Heating and installation for 1-pr in 14763-2

Wayne Larsen

Heating predicted by 29125 and 14763-2 for a 1-pr AWG 23 cable

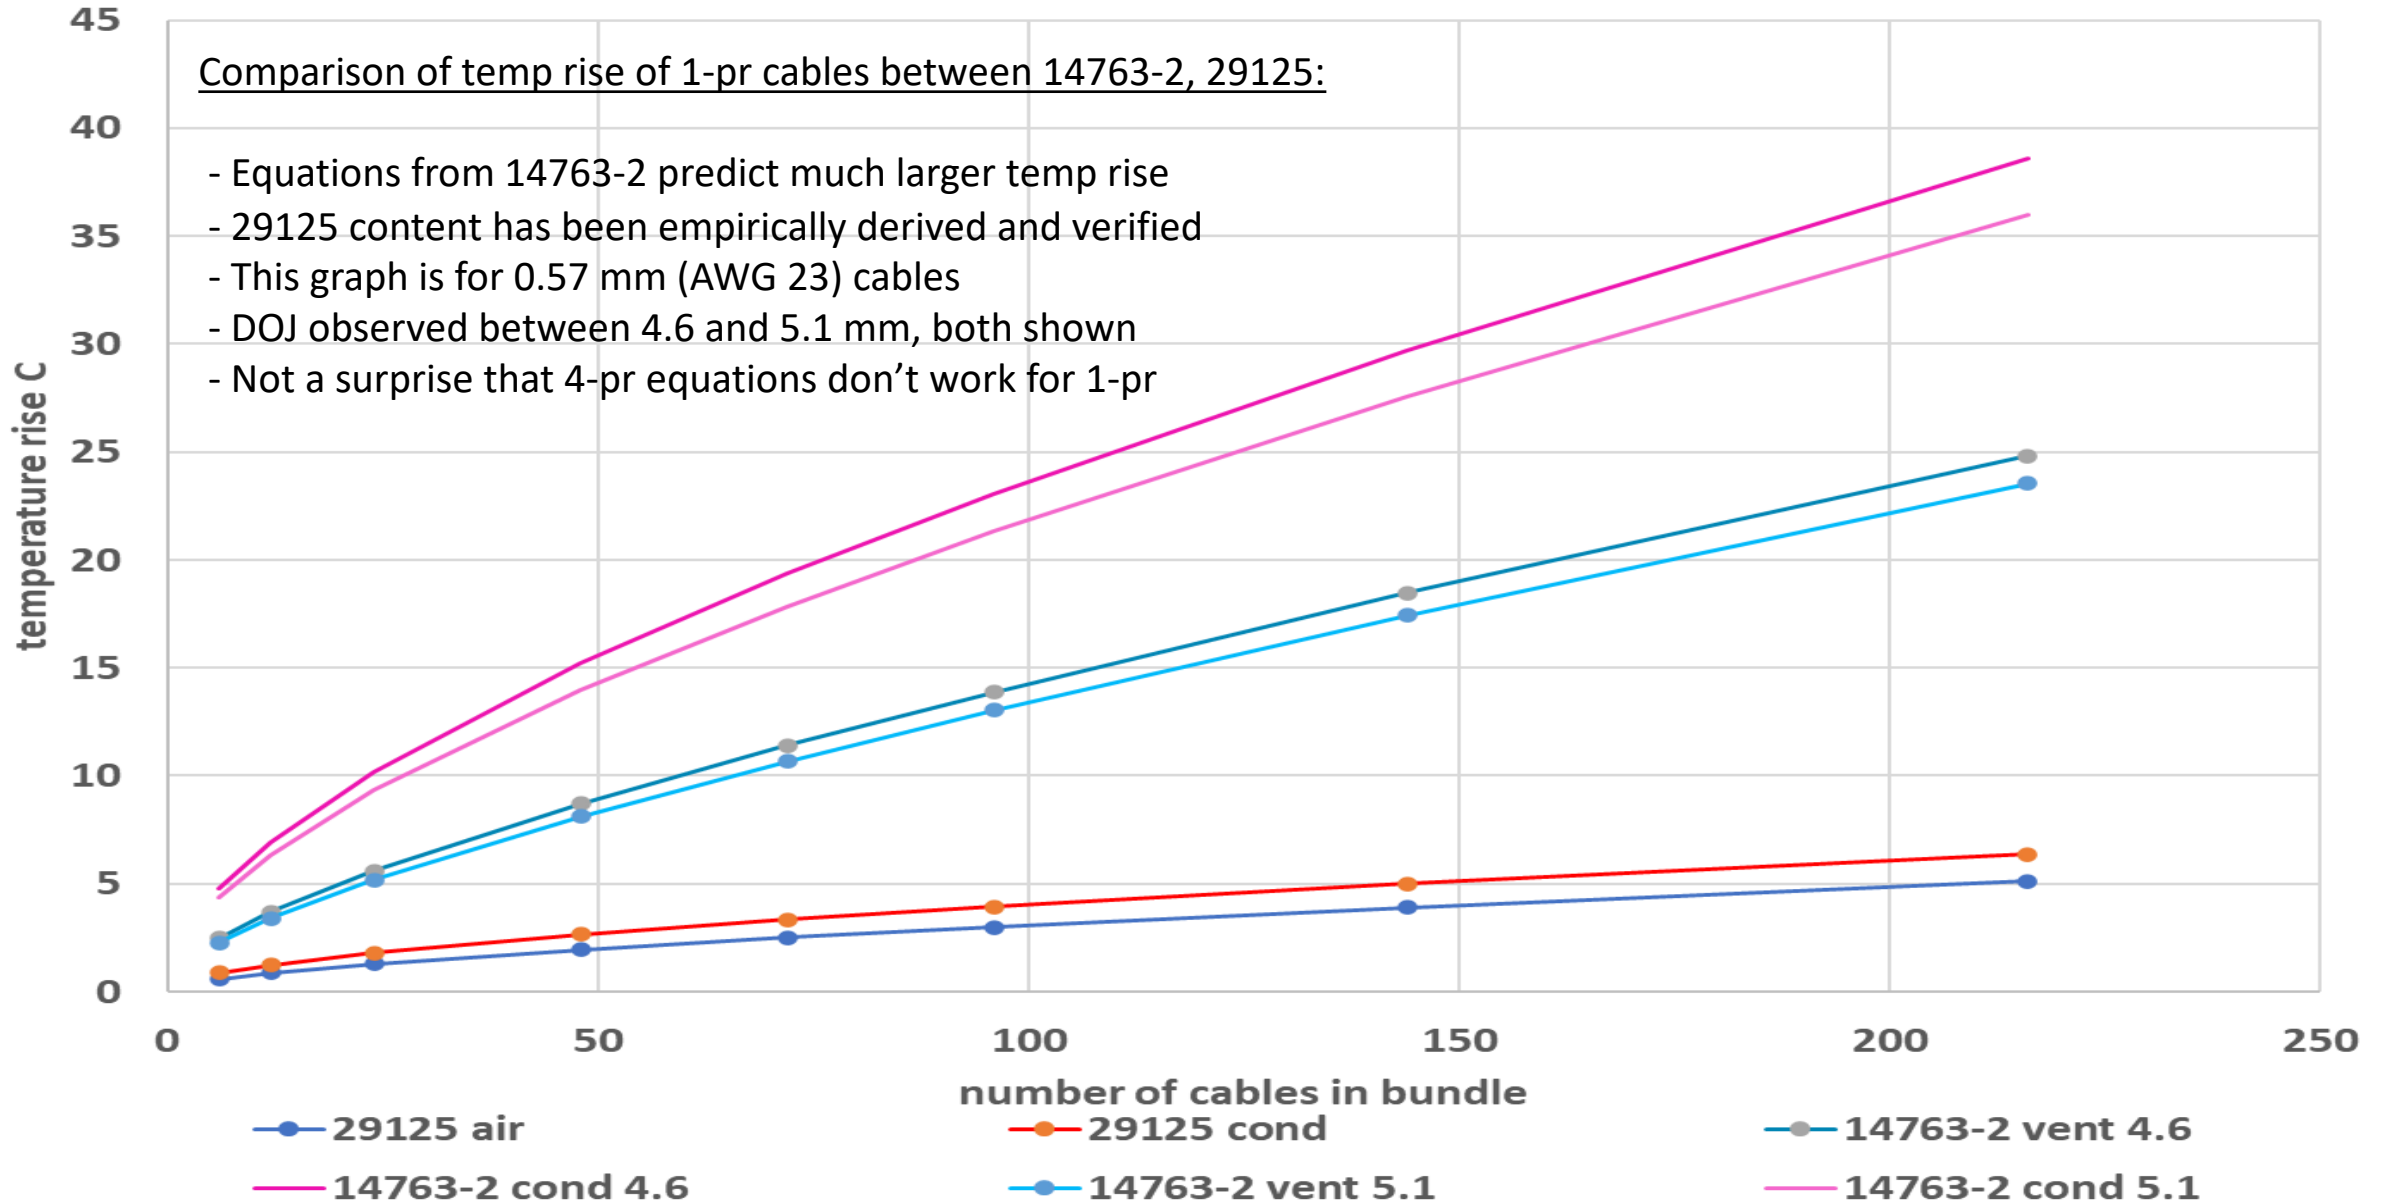
A new model is needed for
1-pr heating in 14763-2
